SUBDIVISION STAFF REPORT Date: August 5, 2004

DEVELOPMENT NAME Greenewood Subdivision

LOCATION 251 South McGregor Avenue

<u>CONTEMPLATED USE</u> Six Lot, Single-Family Residential Subdivision with Reduced Front Setbacks and a Gated Private Street

SITE PLAN

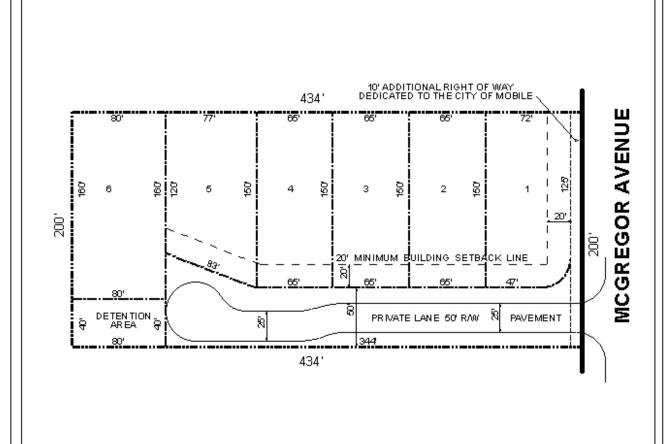
The plat indicates dedication of additional right-of-way to provide 40' from centerline, in conformance with the Major Street Plan. The plan also indicates only one point of access, the proposed private street, thereby providing adequate access management; providing that a condition is placed on any approvals denying Lot 1 direct access to McGregor Avenue.

The plat also indicates a reduced front setback for lots 1-5. No other reduced setbacks are shown, therefore, standard side and rear setbacks and site coverage requirements will be applicable. Additionally, an appropriate setback for Lot 6 will be required on the final plat.

There is an existing dwelling located on the site. This dwelling should be removed prior to recording of the final plat if the PUD and subdivision are approved.

The plat indicates the detention for the site is to be provided in the Southwest corner of the site. The Engineering Department comments express concern over the underground, and will be in compliance with the Engineering Department's requirements for a 100 year flood, with a 10 year flood release. The underground detention will be located in an easement along the rear of lots as opposed to within a common area. As with any development, the Engineering Department will have final approval of the detention facilities.

RECOMMENDATION Planned Unit Development: based on the preceding, it is recommended that this application be approved subject to the following conditions: 1) dedication of sufficient right-of-way along McGregor Avenue to provide

40' from centerline, as shown on the plan submitted; 2) full compliance with the comments from the City Engineering Department; 3) full compliance with the private street requirements of the Subdivision Regulations; 4) the gate to remain operational and in use, if gate ceases to be used, the street must be brought into compliance with city standards and dedicated to the city; 5) compliance with standard side and rear setbacks and site coverage requirements; and 6) full compliance with all municipal codes and ordinances.
